# Rezoning Transportation Analysis

Petition Number: #2022-091

## Revision Log:

Date	Description
11-28-22	First Review (IW)
01-27-23	Second Review (IW)
02-13-23	Third Review (DR)
02-22-23	Forth Review (IW)
03-28-23	Fifth Review (IW)

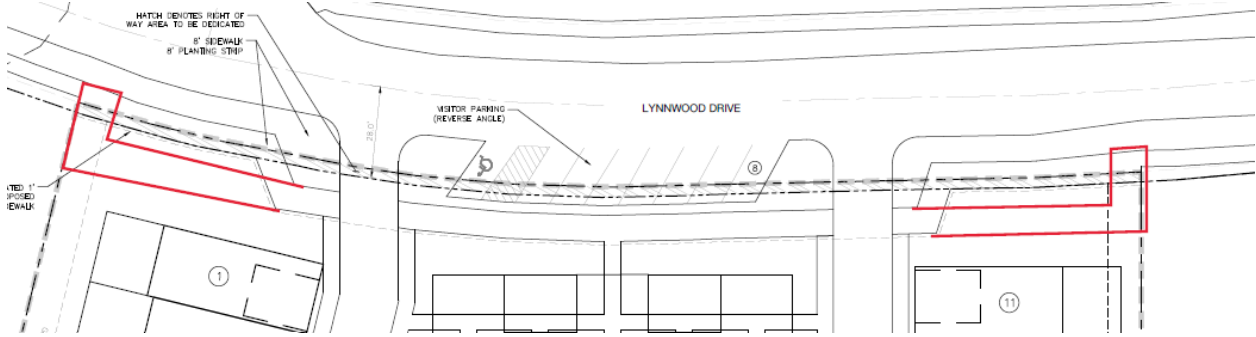
- ~~1. **Outstanding comment from 11-28-22** **Curblin**: The proposed zoning district has a setback measured from back of the existing or proposed future curblin.~~
  - ~~a. **Lynnwood Drive**: The future location of curb and gutter should follow the CLDSM Local Residential Medium Street which is measured at 13 feet from the centerline of the roadway to the BOC.~~

~~**Clarifying comment 01-26-23**: Site plan should show dimension from centerline to back of curb.~~

~~Label and dimension the curb and gutter from the centerline for each road on the site plan.~~
- ~~2. **Traffic Study**:  
A Traffic Impact Study (TIS) is not necessary for the complete review of this petition due to the site generating less than 2,500 daily trips. If during the permitting process the site generates more than 2,500 daily trips, then a traffic study will be required.~~
- ~~3. Revise conditional note(s) to commit to dedicate 28 feet of right of way from the road centerline in coordination per CLDSM Local Residential Medium Street. The site plan shall label and dimension the right of way from the road centerline.~~
- ~~4. Revise site plan and conditional note(s) to remove angled parking and install parallel parking on Lynnwood Drive.~~
